URBAN DESIGN BRIEF

SITE PLAN CONTROL

SUBJECT SITE: 541-561 SOMME STREET

REPORT DATE: APRIL 21, 2025

Figure 1: Extract of Site Plan (Source: Redline Architecture)

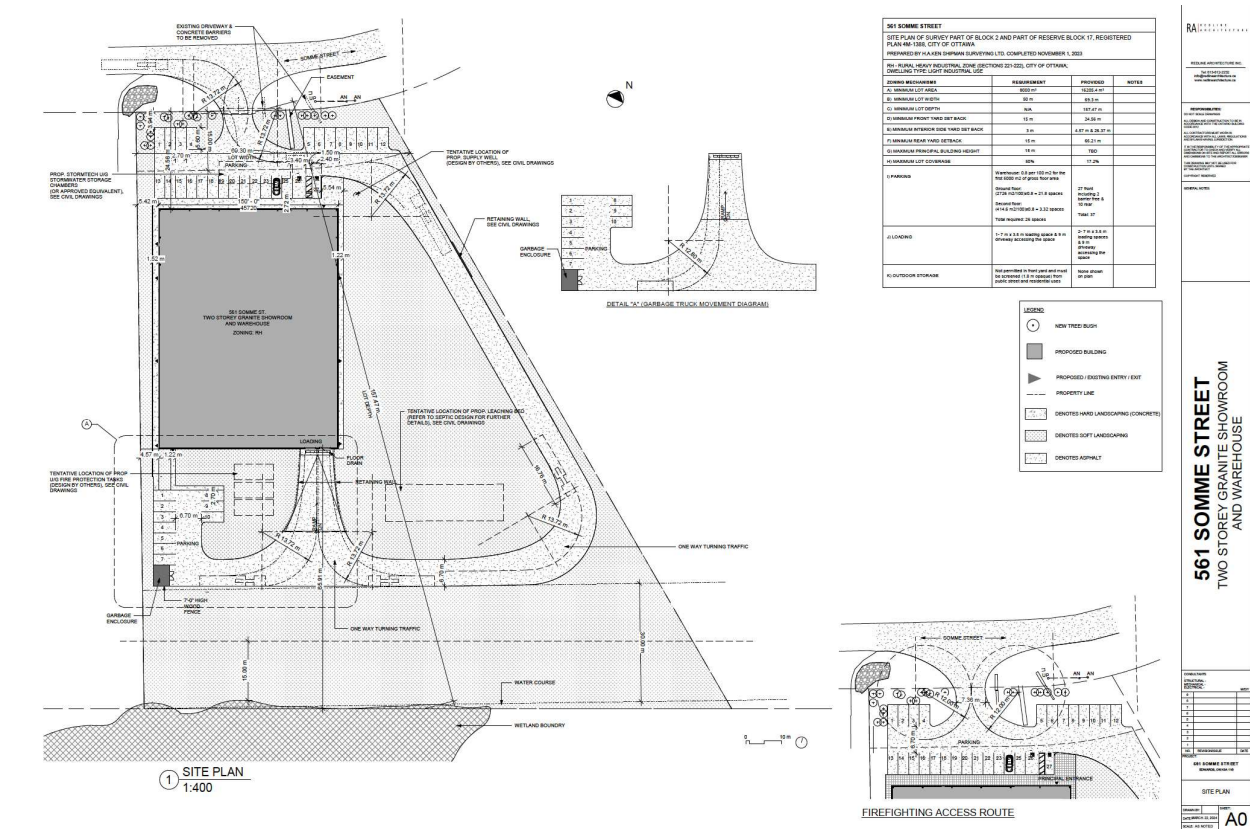
We recommend providing landscaping and new tree planting at the front of the property.	Trees and landscaping have been added to the front of the property. In working with HydroOttawa, we have learned that there is an easement, poles and tie-backs that significantly encumber the frontage. Therefore, no landscaping is provided where hydro infrastructure is existing.

What is happening in the large areas of land left over at the rear of the site and beside the building? Please indicate on the site plan/landscape plan and provide landscaping and trees if possible/suitable.	This area has been reserved for possible future development.
--	---
